Please find below a memo summarising Biologic Environmental Survey's (Biologic) response to select Environmental Protection Authority (EPA) comments requesting additional information relating to vertebrate fauna on the Telfer – Havieron Gold Mining Project (the Project) proposal referral documentation (EO Ref No. APP-0000338).

This memo specifically addresses required amendments number 11, 12, 13, and 14 of EPA's notice requiring information for assessment for the Project.

Newmont is progressing the Telfer – Havieron Gold Mining Project (the Project) proposal and pursuant to section 40(2)a of the *Environmental Protection Acct 1986* (EP Act), the Environmental Protection Authority (EPA) has requested additional information for proposal referral documentation (EO Ref No. APP-0000338) to support the assessment of the proposal. The EPA's request for additional information includes 36 requirements for additional information, of which 16 relate to terrestrial fauna.

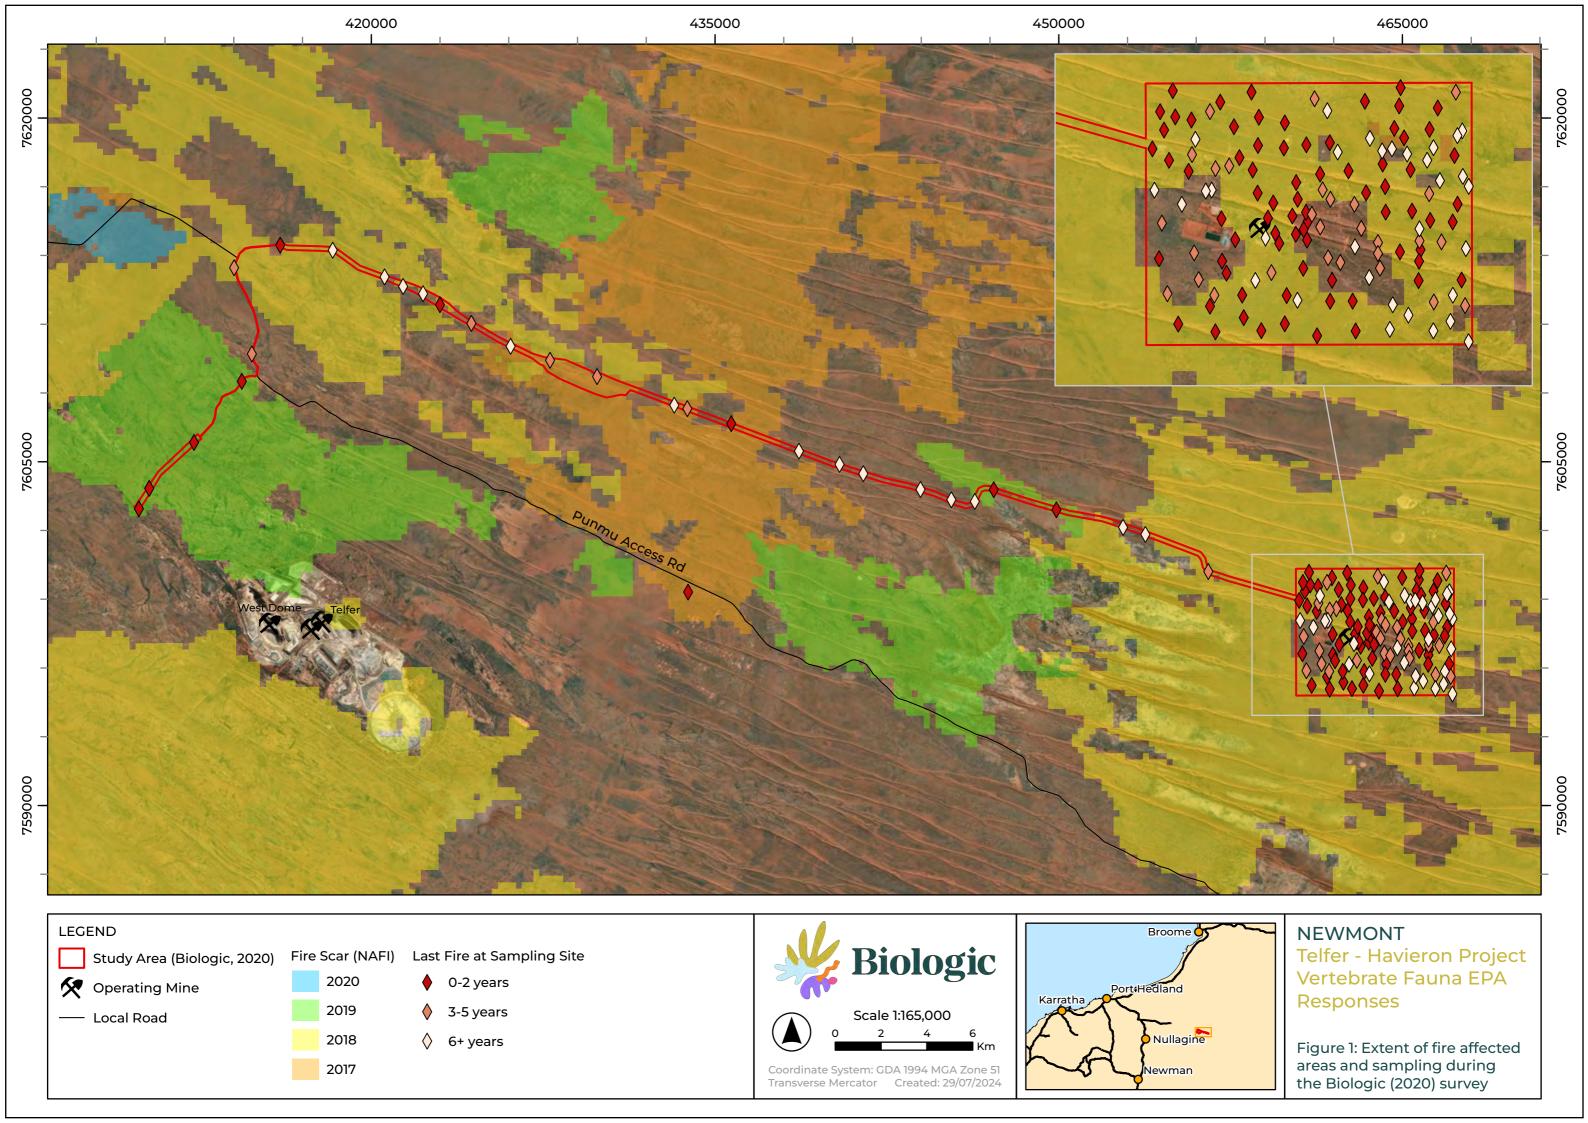
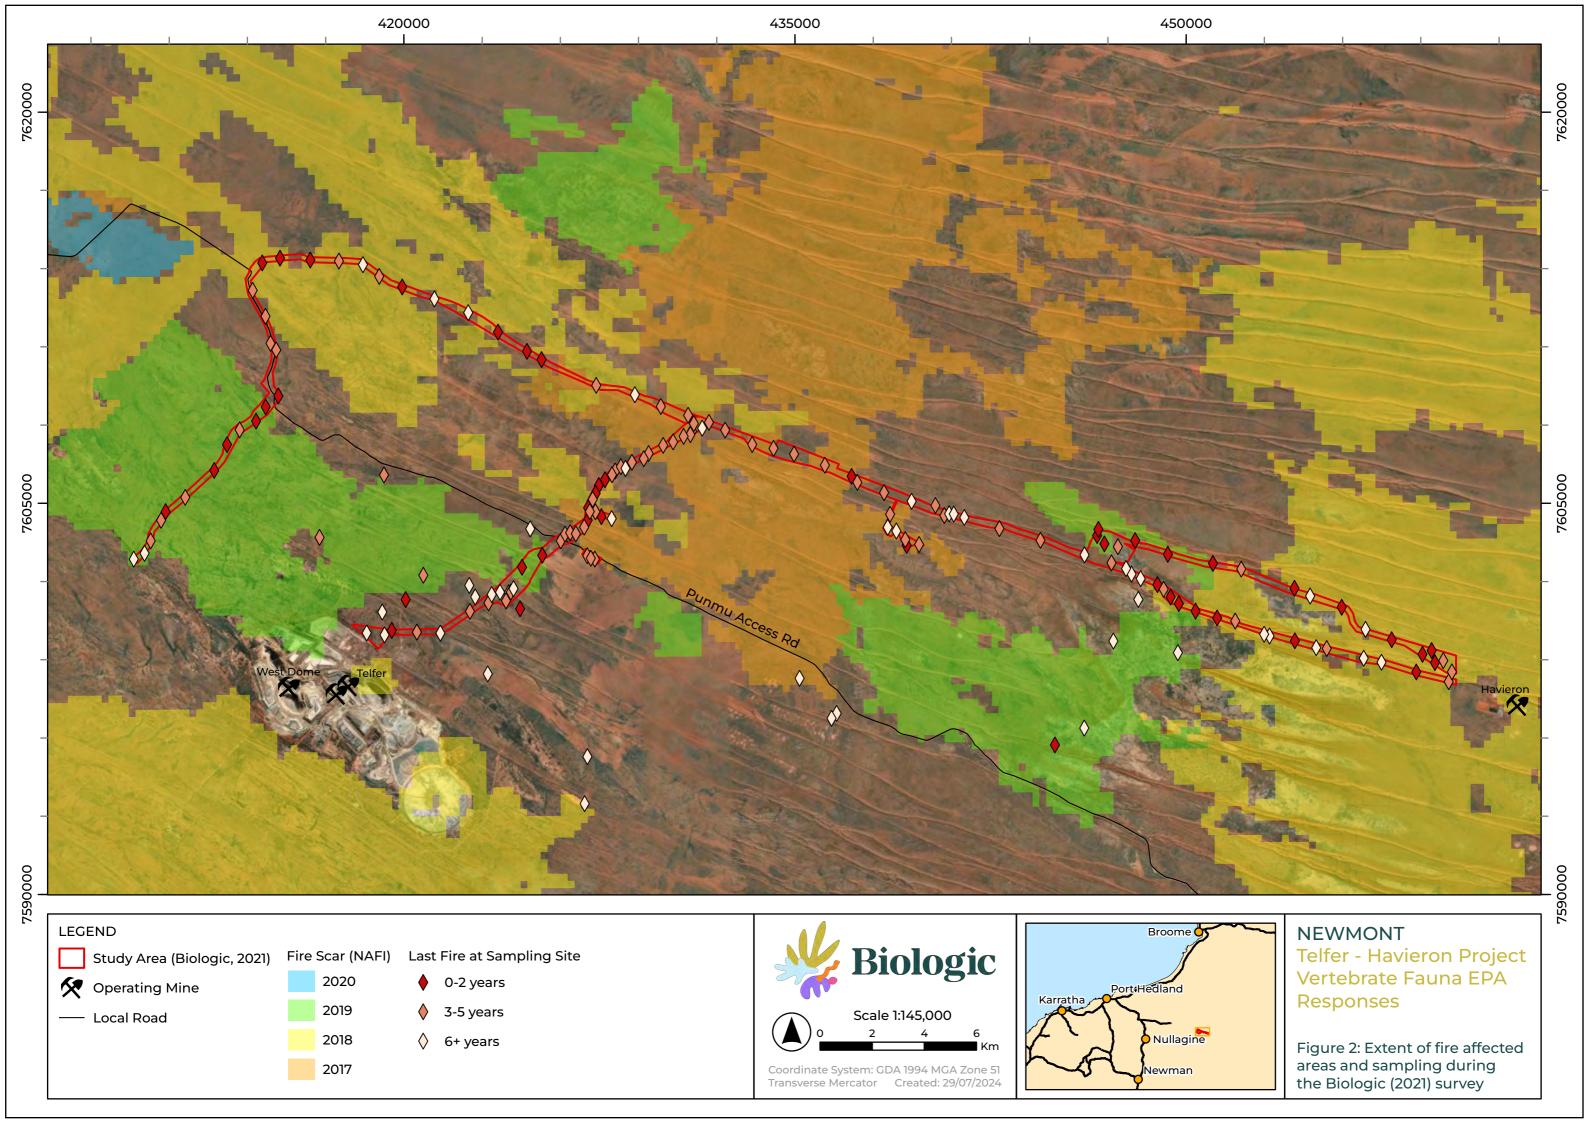
The terrestrial fauna survey reports (Biologic, 2020, 2021) in RSD Appendix D, state access restrictions and the occurrence of a large-scale fire restricted the locations of the trapping sites (Biologic, 2020, P.54; 2021, p.43).

However, it is not clear how this limited the survey design and effort and the impact of fire on fauna habitats has not been illustrated spatially or quantified.

Provide figures to demonstrate the areas impacted by fire and identify any access restrictions

Northern Australia Fire Information (NAFI) fire scar mapping shows widespread occurrence of fire over parts of the Biologic (2020) and Biologic (2021) study areas in 2017–2019 (Figure 1; Figure 2); however, it should be noted that the broad scale of this mapping can result in overrepresentation of affected areas. The observed first history across the study areas (see Appendix E (p.138) of Biologic (2020) and Appendix E (p.146) of Biologic (2021)), as determined from on-ground habitat assessments, shown in Figure 1 and Figure 2 show that there was a broader occurrence of areas which could be sampled that were not affected by the recent fires. Based on the on-ground habitat assessments (including all sampling locations), including fire history, undertaken within the Biologic (2020, 2021) study areas, a total of 28% of sites were located within areas where first age was assessed as old (6+ years since fire) (n = 92 sites), 32% as moderate (3–5 years since fire) (n = 104 sites) and 40% as recent (2–5 years

since fire) (n = 131 sites) (Table 1). Sampling within these areas facilitated sufficient sampling within the study areas to achieve the overarching objectives of the surveys as collection of contextual data, with a focus on significant species, required to inform the Project's environmental approvals.
